ECU00002175: Proposed Corriegarth 2 Wind Farm Supplementary Environmental Information (SEI): Response to Ironside Farrar Stage 1 Checking Report – Review of Peat Slide Risk Assessment

In reference to the above project, Arcus Consultancy Services Ltd (Arcus) has prepared this clarification letter in response to the Ironside Farrar Ltd Stage 1 Checking Report (the Checking Report) dated August 2022. This response supersedes the previous 'draft' version circulated on 28th September, and has been informed by discussion with Ironside Farrar and the Energy Consents Unit (ECU) on 30th September 2022.

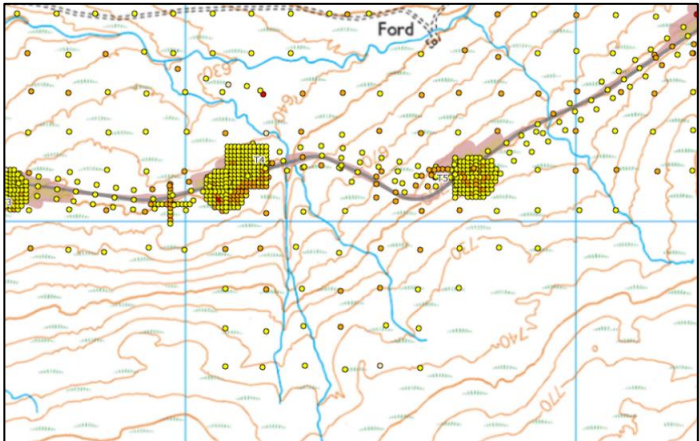
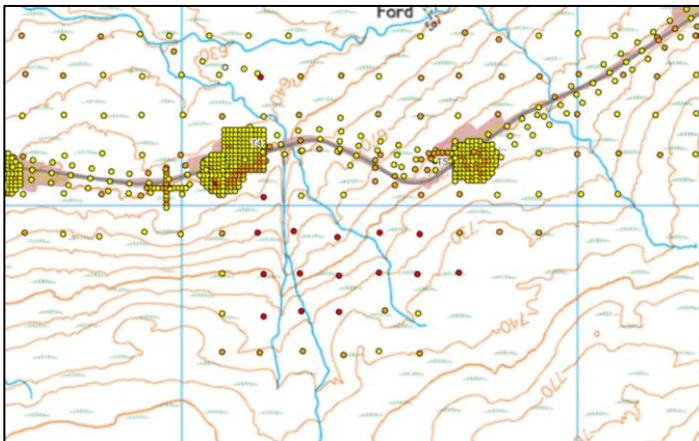
IF Recommendation (requiring response)	Arcus Response
<i>Deviations from the 2017 Peatland Survey Guidance require justification, particularly the track to T16 which appears to be in a higher likelihood area.</i>	The vast majority of the site has been probed in full accordance with the 2017 Peatland Survey Guidance. The deviation from the guidance is limited solely to the section of track at T16 track, and is a surveying oversight (due to the survey focus on new SEI infrastructure and areas identified as lacking from the EIA checking report). There was probing within this area but not to the extent stated within the guidance. To address this, a conservative approach has been taken and the area zoned as a conservative higher likelihood and the track proposed as floating due to the peat depths and permissible gradients. This approach ensures the avoidance of peat excavation, which in turn reduces the risk of slide. It is noted the majority of probes within the zone were recorded as Low peat slide risk. Pre-construction intrusive ground investigations will take place which will provide gather further data in the areas of T16 track and will inform any potential additional mitigation designed during the detailed design stage. Further detail on mitigation is outlined below.

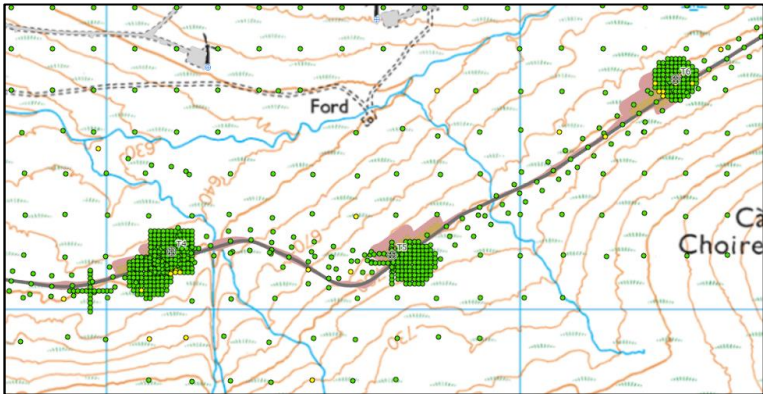
<i>Geomorphology mapping to be updated in line with ECUBPG 4.4.1.</i>	Figure 13.1.4 of the SEI presents the geomorphology mapping. Geomorphology mapping illustrates top and bottom of key slopes, watercourses and polygon extents of haggings/cracks due to the extensive nature of such features. Clarification Figure 1 appended to this letter presents the geomorphology mapping within the site with the addition of existing drainage features now included. Clarification Figure 1 also presents locations of the potential historical slide referenced in the PSRA report submitted with the SEI. Clarification Figure 1 has been prepared based on documented site survey details and aerial photography.
<i>Confirmation on why "slip material" has not been used in any of the calculations despite it being encountered south of the site.</i>	Underlying substrate estimates were used in the calculations. The consistent nature of the cracks and hags is indicative of areas of extensive erosion/haggings/bare peat rather than slip material. The 'slip material' referenced in the PSRA report was out with the footprint of the proposed infrastructure area by distances between 200m and 300m respectively, therefore the closest probes directly beneath the development took precedent over the wider area in terms of the substrate values used. The use of slip material value has been assessed for the relevant probes in further analysis to ascertain the potential changes this could have on hazard assessment. This was the only part of the site that this approach was relevant for as no other possible historic slides were noted across the wider site, and the likelihood is that it was due to the local steepness given the steep topography and surrounding ground/surface conditions to the south of T4 and T5 and associated tracks. The extracts below present the 'without' and 'with' ratings. Plate 1a: Without 'Slip Material' Substrate Value – Extract at T4 and T5  Plate 1b: With 'Slip Material' Substrate Value – Extract at T4 and T5

The probes within the vicinity of the possible historical slip materials presented high risk when the 'slip material' substrate value was used in the analysis. However, this area is upslope of the development footprint, approximately 240 m from the nearest element of infrastructure, and no works are proposed in these areas associated with the wind farm construction. In addition, the southern site area is well drained by watercourses, as apparent from the above map, and the topography is sloping, from south to north, with peat coring recording low-medium Von Post values also. It is also proposed that the area be fenced off to ensure that there will be no inadvertent excavation or access. While the potential for peat slide is greater in the area of the 'possible historical slide', the potential human activities representative of triggering factors for slide will be reduced through mitigation. The mitigation will include 'no stockpile zones'; limiting the movement of heavy plant/tracking; installation of pre-drainage ditches; and preventing access to areas of high risk peat slide which are located out with the footprint but upslope of the development. The construction drainage measures will remain in place and will continue to provide mitigation long term, throughout the operational period. A mitigation plan has been developed to illustrate the mitigation approach to be adopted during construction; these measures are illustrated in Clarification Figure 3 (and 3a – 3d) in Appendix A of this letter.

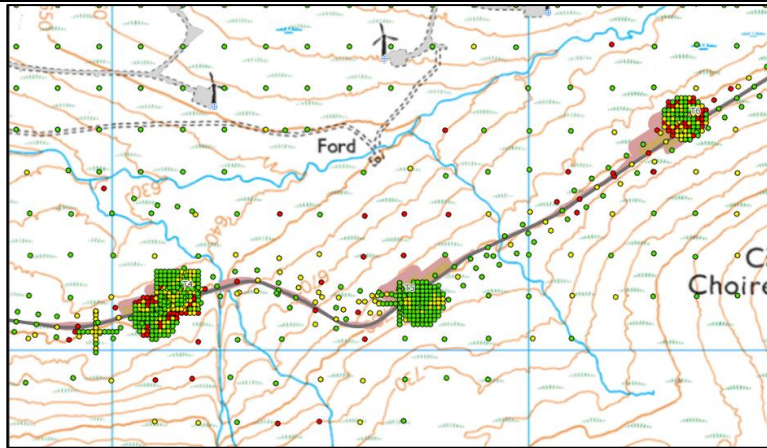
<i>FoS analysis has not used the most conservative literature values, it has also only considered a drained analysis. Mapping does not show elevated risk at the south of the site where potential historic slips are noted. Therefore, comment is requested on why more conservative values haven't been used and whether sensitivity analysis using the undrained equation, including loading, would represent a realistic worst case scenario for the floating track sections.</i>	Following the analysis and review of the comments from Ironside Farrar, the focus of the response was the southern site area, in the vicinity of T3 to T6, where the PSRA hazard zones were presented as medium risk areas. Given the extent of erosion, drainage and ditches, and sloping conditions in the south of the site, the peat was assessed as being relatively well drained. Coring in the southern site area suggested that only the deepest peat close to the substrate interface was of moderate to strong decomposition (Von Post Scale of H7-H8) with the top 1.0m largely recording Von Post scale of H3 to H4; very slightly and slightly decomposed. The peat cores obtained in this area also held their form and did not represent a slurry state. The evidence from coring and site conditions informed the use of a mean value for friction and cohesion as opposed to the worst case scenario. However, a sensitivity analysis has been undertaken using the most conservative literature values to assess the difference in the FoS assessment values. Generally, the sensitivity analysis indicated that the use of the lower conservative values would present localised High risk areas, which were largely concentrated to the southern turbines specifically T4 and T6, and some sections of track. Plate 2a: FoS using mean literature Cohesion and Friction Values – Extract at T4 to T6  Plate 2b: FoS sensitivity analysis using conservative literature Cohesion and Friction Values – Extract at T4 to T6

It should be noted however that these high risk probes are still a minority within a highly populated low and locally moderate factor of safety.

Overall the high risk probes lie within areas already conservatively zoned as Medium Hazard Risk Zones and would therefore be subject to both the detailed mitigation during construction, the use of best practices, and enhanced/location specific mitigation in line with PSRA and this letter (and associated Clarification Figure 3 (and 3a to 3d). 3

Plate 3a: SEI Hazard Zonation Extract

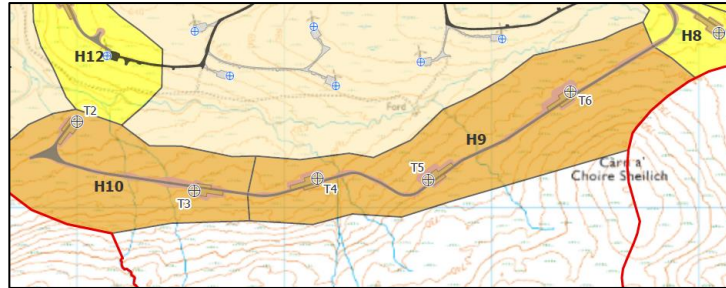
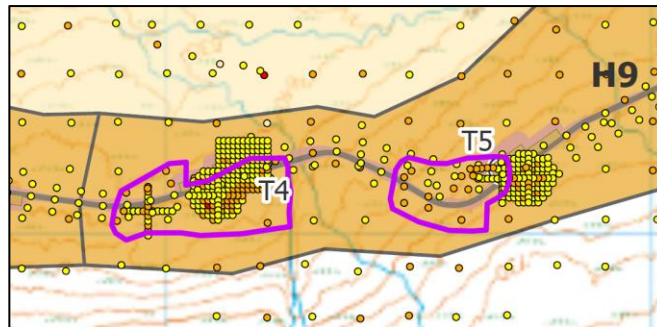
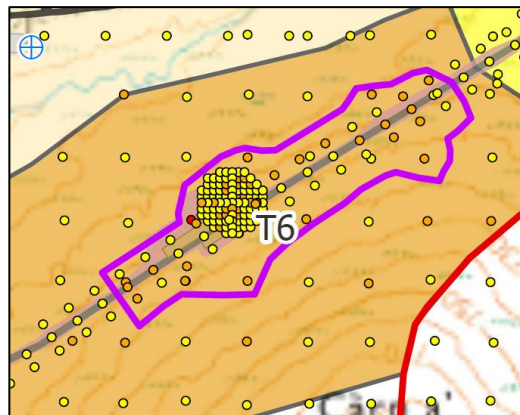
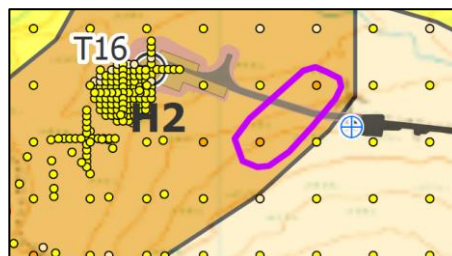
Further clarity is sought in the definition of medium risk areas displayed in figure 13.1.10, are these medium risk areas extrapolated from smaller pockets of medium risk to

display a worse case scenario? If so, more specific mitigation should be provided for infrastructure specific locations in order to satisfy the guidance.

Review of the hazard rank zones and hazard rank points illustrated that the medium risk zones presented in the SEI are wider than the Development footprint, and there are a number of distinctive medium risk points considered during analysis which lay within a greater population of low risk points, demonstrated in the below extracts as 'Potentially Reduced Extent of Risk Areas'. The following example extracts in Plates 3a-d illustrate how the hazard zones are an overall conservative approach with the majority of points in the 'medium risk' areas actually recorded as Low risk. The key areas for consideration were the extensively zoned medium risk areas in the south of the site, between T3 and T6 (where topography was generally steep) and a localised section at T16 (where probing was limited). The hazard zonation points across the remainder of the proposed development were almost entirely Low or negligible risk, with exception of sparsely located occasional medium risk.

Clarification Figure 2 is appended to this letter to illustrate how the zonation presents a more conservative approach against the individual point ratings where the majority of point specific ratings are Low.

Outline Mitigation Within Medium Risk Zones
Clarification Figure 3

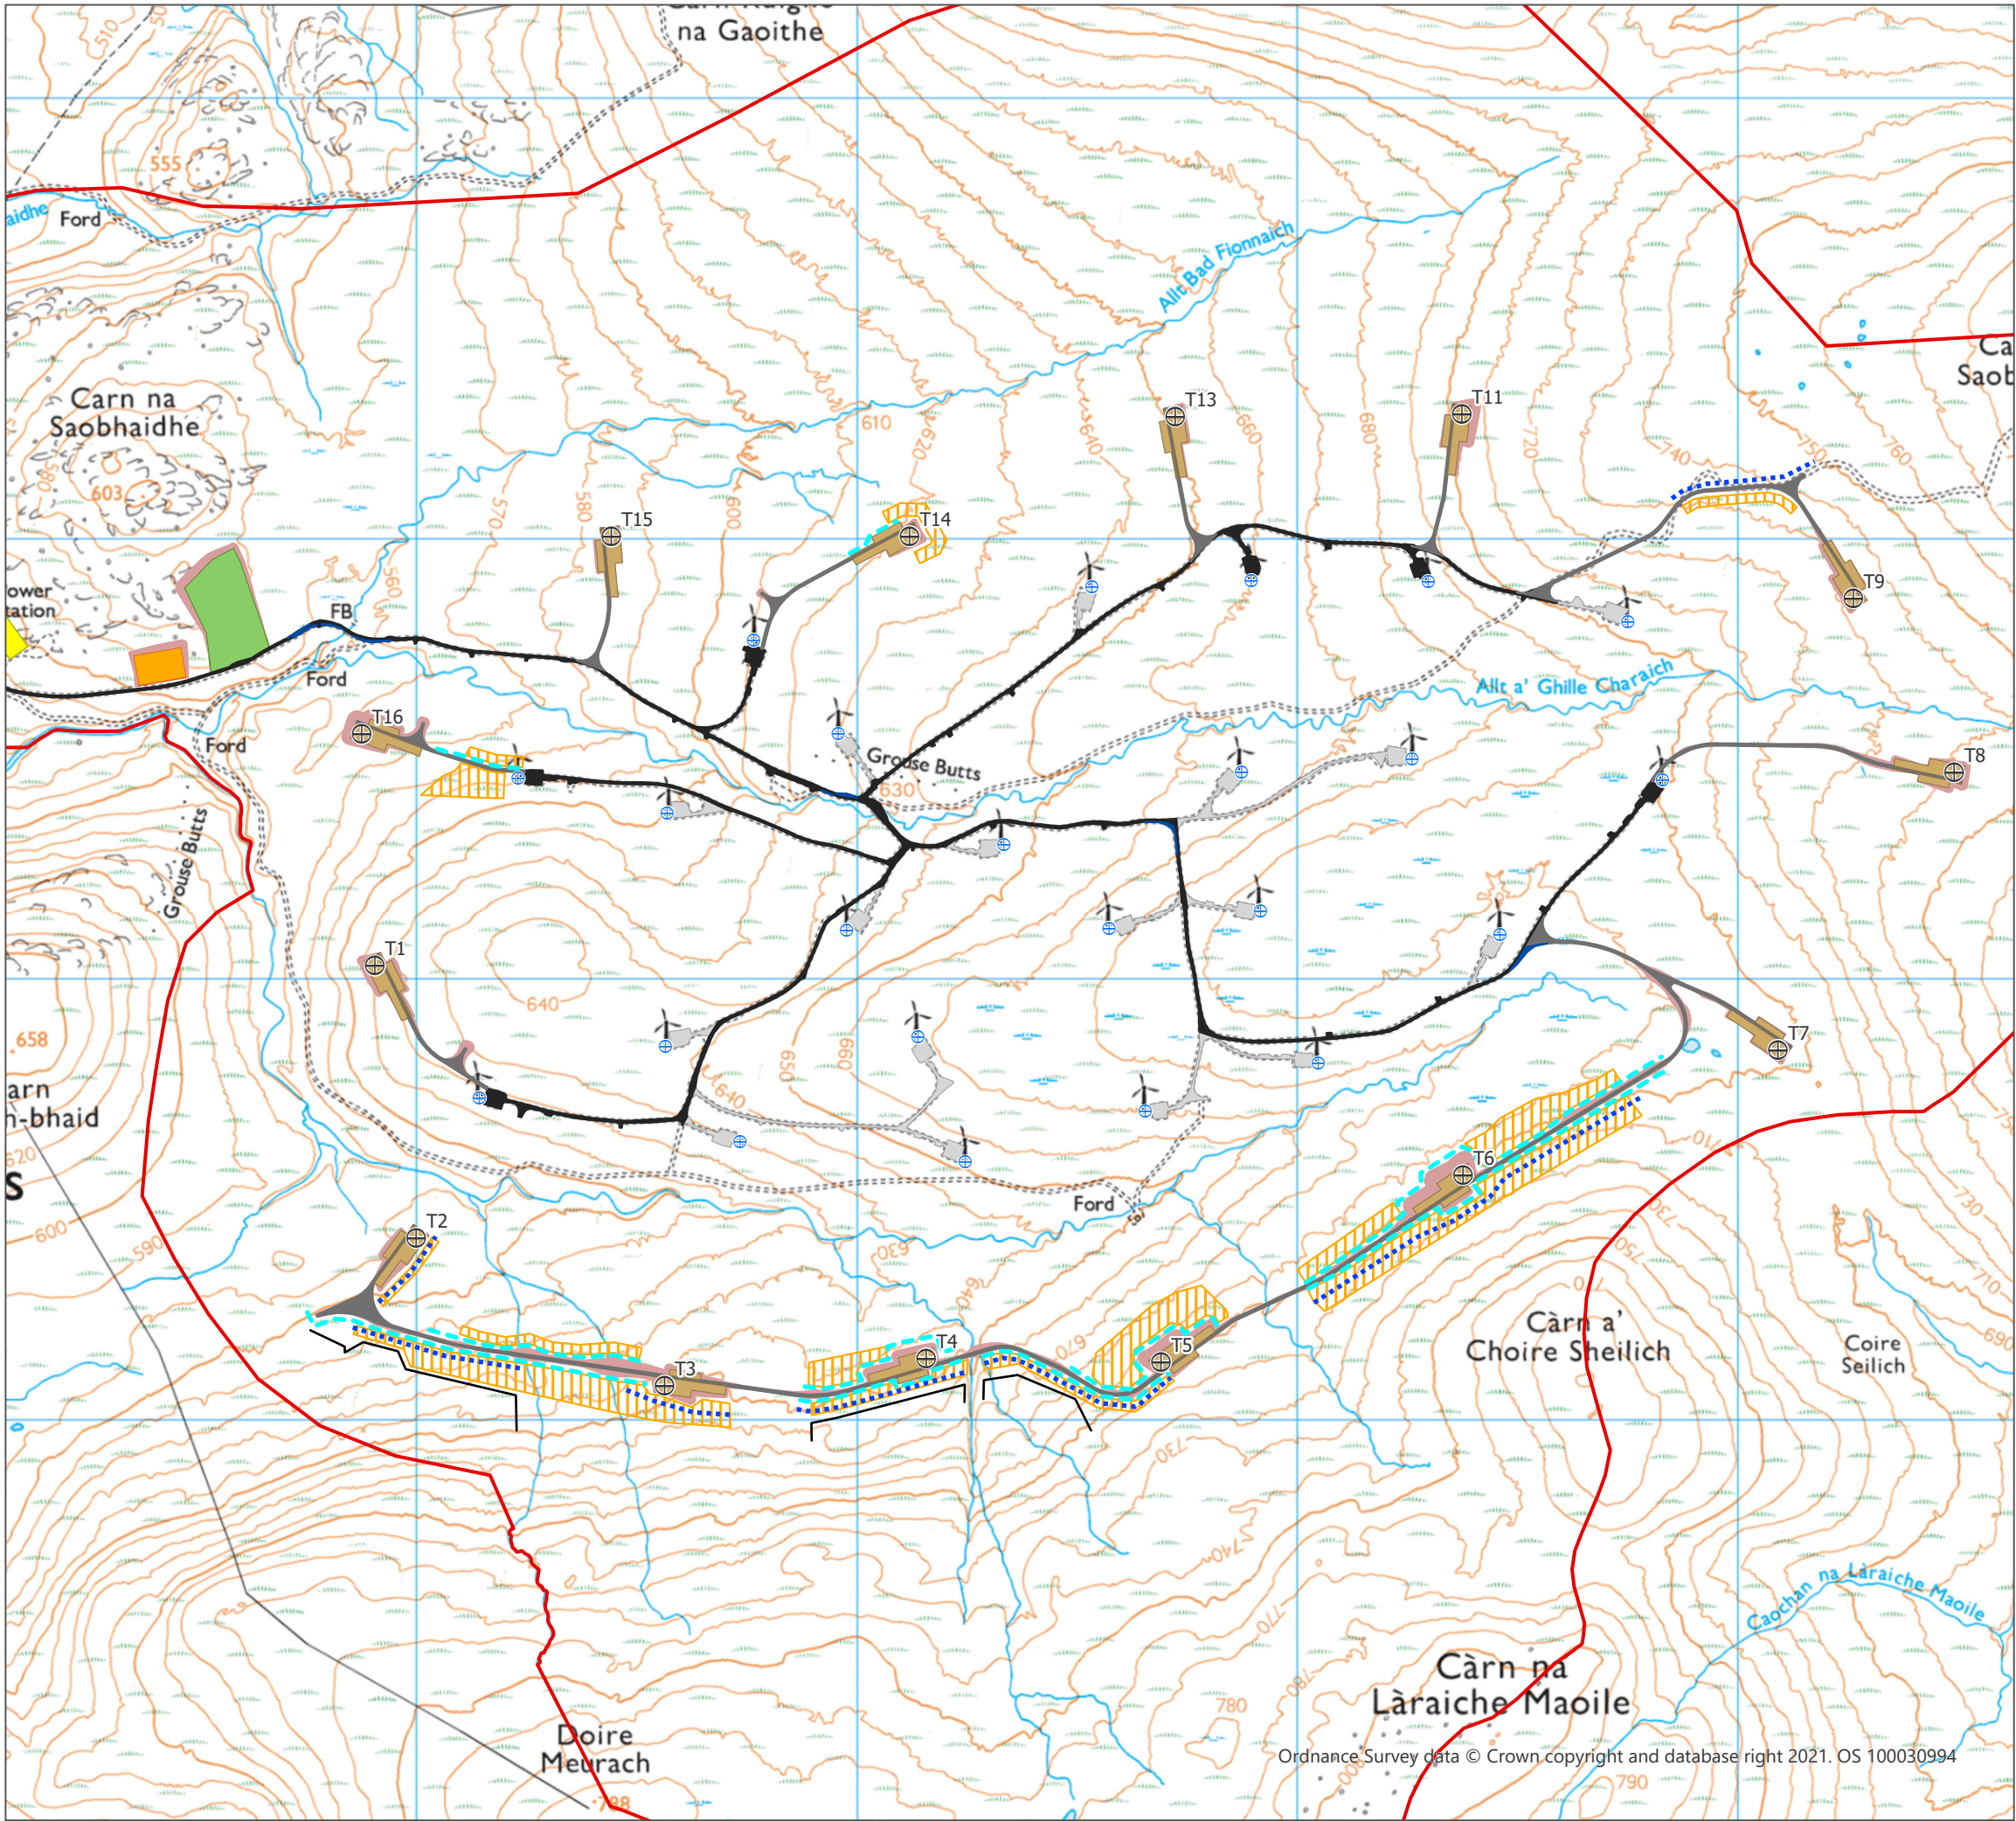
The mitigation provided in Table 15 is considered generic and not specifically targeted to the risks identified in the risk assessment. Further detail / clarification of practices is required particularly in the case of medium risk zones in order to satisfy the ECUBPG.

Proposed mitigation is illustrated on Clarification Figure 3 (and Figure 3a to 3d) included in Appendix A of this letter. These measures presented on Clarification Figure 3 are the minimum proposals that will be in place during construction, however intrusive geotechnical investigation and detailed design will inform the

Specific mitigation in the areas of medium risk hazard as identified on Clarification Figure 3 (and Figure 3a to 3d) includes the following:

- Work in medium risk areas would be under supervision of the Geotechnical Clerk of Works (GCoW) and Environmental Clerk of Works (ECoW).
- Stockpiling and side casting will be prohibited in the 'no stockpile zones' within the medium risk peat slide areas as identified on Clarification Figure 3;
